THE GLIDING FEDERATION OF AUSTRALIA

GFA AD 436

GFA AIRWORTHINESS DIRECTIVE

BULLETIN No BA-047/50-3/94 "PUCHACZ"

Fig. 1

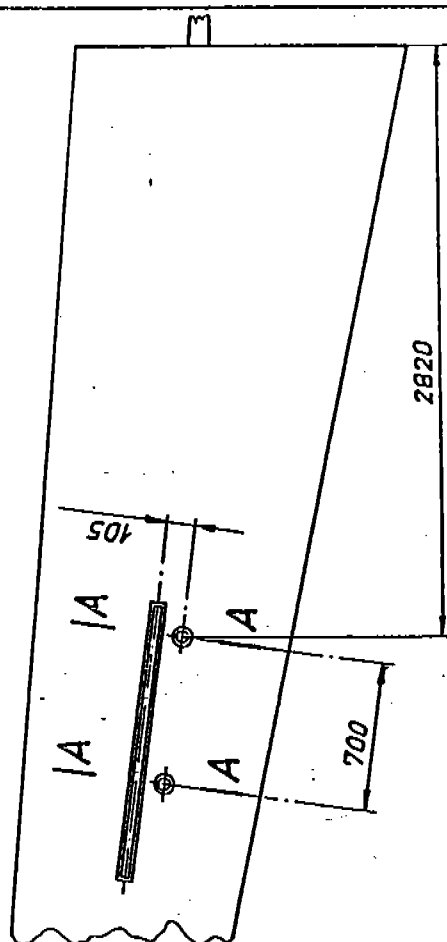
5.1. Trace the axis and cut-off the ϕ 70 mm openings on the lower covering of lefthand and righthand wing acc. to the sketch on Fig. 1.

Fig. 4

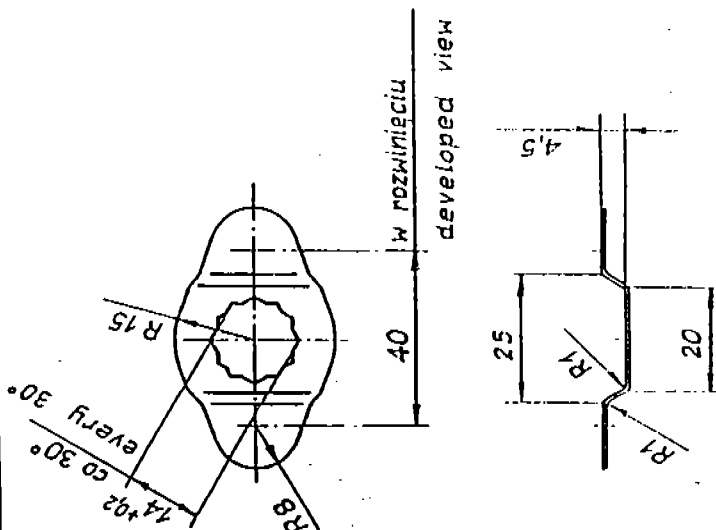
4.1. Sketch of the cap - Fig. 4

Fig. 3

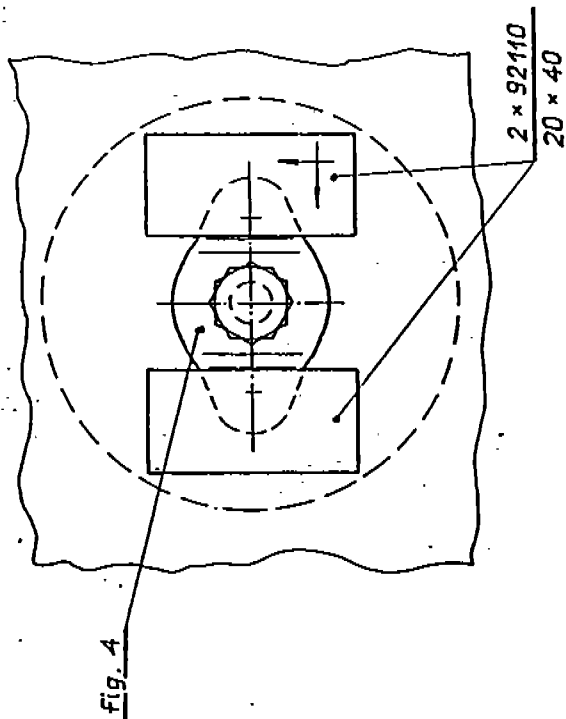
5.5. Glue-up onto the air brake boxes the degreased securing metal pads acc. to Fig. 3.
